Legon Fire Station Child Lab and E A Boateng Road Reconstruction Brief

Correct the selected area in the existing University of Ghana bicycle exploration game using 14 paired street comparisons, three annotated real aerial maps and six game overview references. The principal task is to replace unsupported tall institutional templates with the observed low buildings, yards, roof forms and connected road landscape. This brief follows the supplied sample format and addresses this new section only.

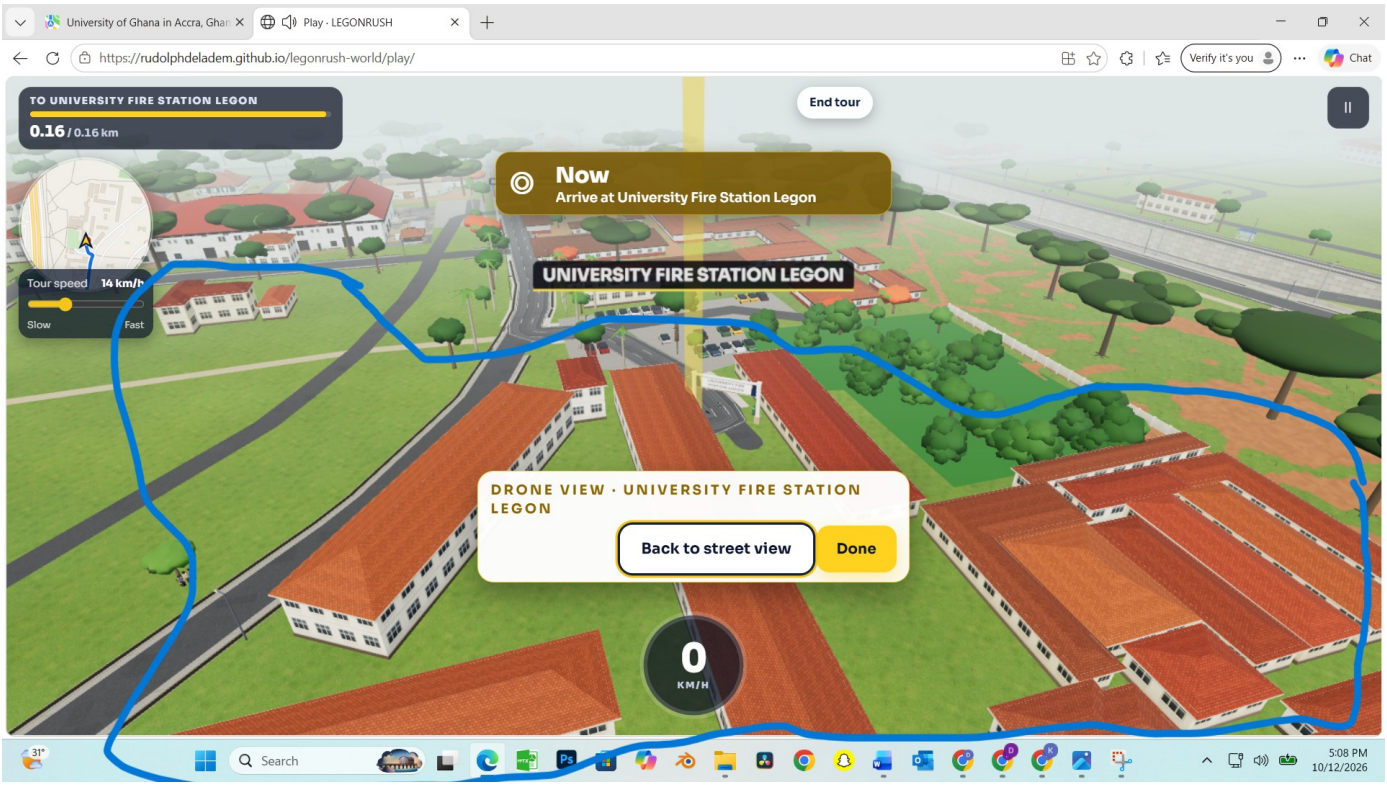
From this angle the selected area still reads as a generic institutional campus: elongated roof bars, almost identical white facades, broad lawn sheets and regularly placed palms. The road-mouth and parking apron dominate the foreground, while the real service architecture and irregular enclosure are missing.

Check road-mouth shape against R3 and Pair 14 before moving the adjacent buildings. Reconstruct separate low station volumes and practical service access. Adjust each roof length and orientation from the real outline rather than reusing one long bar. Replace the palm repetition with the mixed mature canopy supported by the street views, preserving verified neighbouring assets outside the selected work.

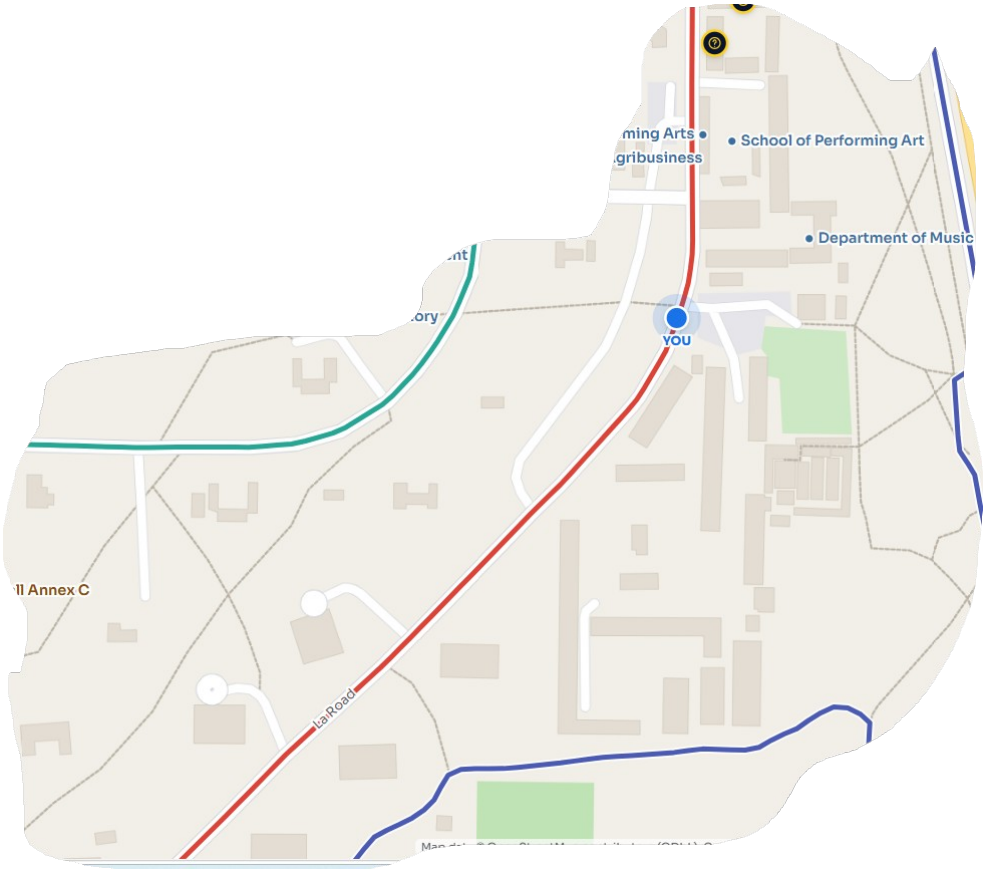
The reverse angle exposes the same excessive roof-bar lengths, unsupported upper floors and simplified grass/woodland boundary. A distant large road corridor is visible, but this crop and the supplied local real maps do not establish all of its geometry or a continuous surveyed connection to every parcel.

Use this view to inspect backs, shared corners and terrain joins of the same replacements. Check that courtyard openings remain open, the station canopy is not a solid roof box and tree density agrees across opposing angles. Preserve distant roads and buildings unless their membership in this correction zone is verified; do not import the earlier Legon Road and La Bawaleshie project from the sample PDF.
